PATENT
App. Ser. No.: 10/600,014
Atty. Dkt. No. ROC920030209US1
PS Ref. No.: IBM/K30209

REMARKS

This is intended as a full and complete response to the Office Action dated December 16, 2005, having a shortened statutory period for response set to expire on March 16, 2006. Please reconsider the claims pending in the application for reasons discussed below.

FIG. 3A

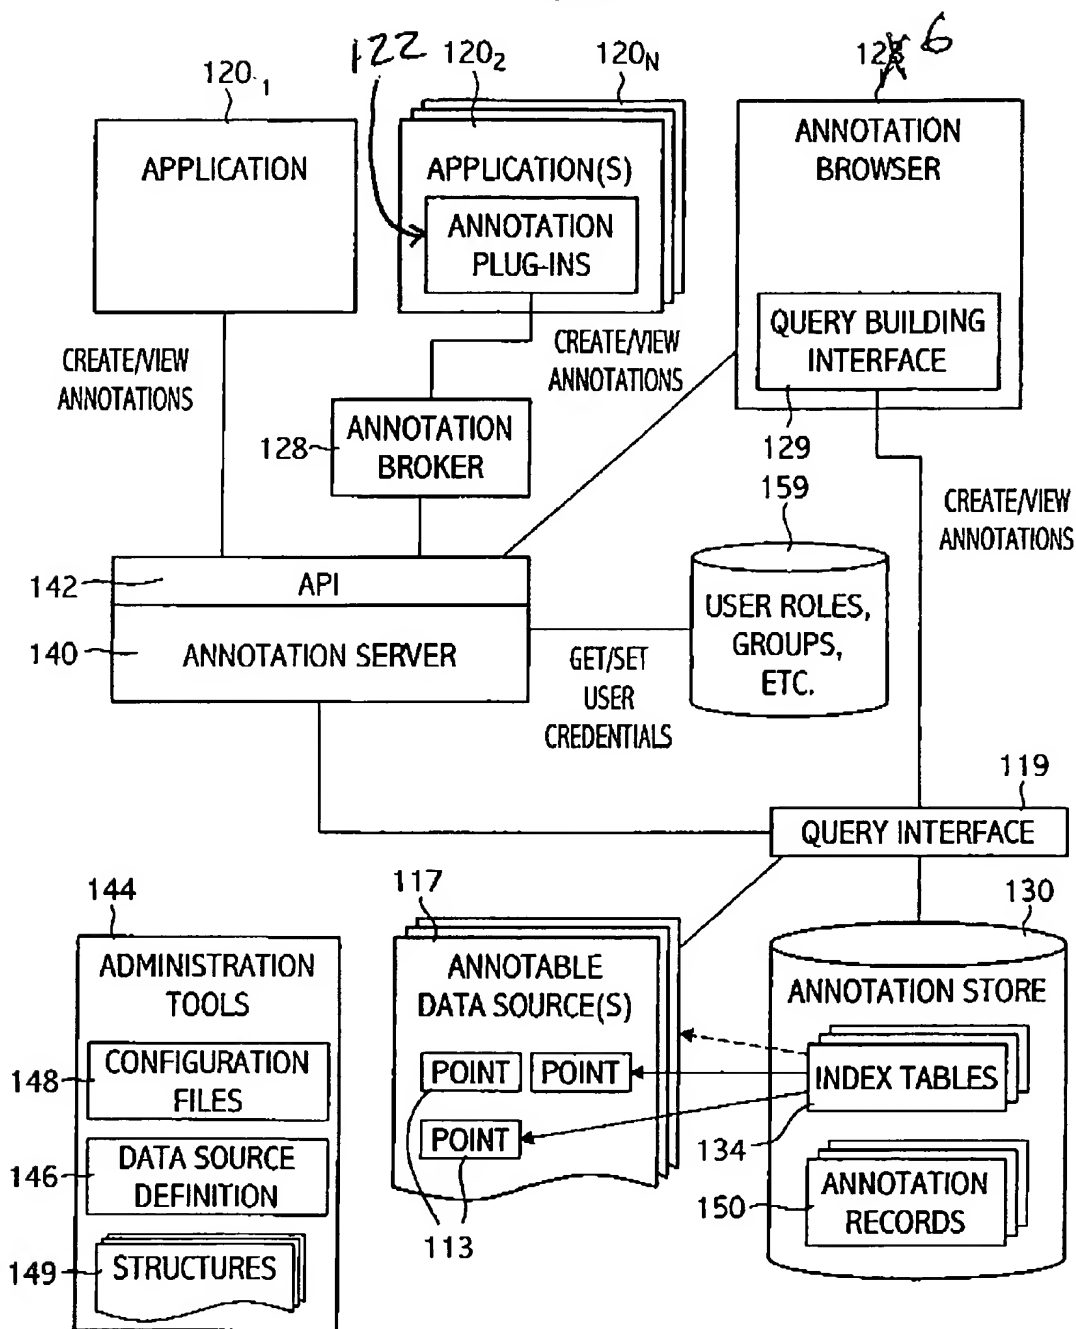
Changes to the specification were made to address the Examiner's objections to the drawings. Furthermore, the attached sheets of drawings include changes to Fig. 3A and Fig. 8A, also to address the Examiner's objections to the drawings.
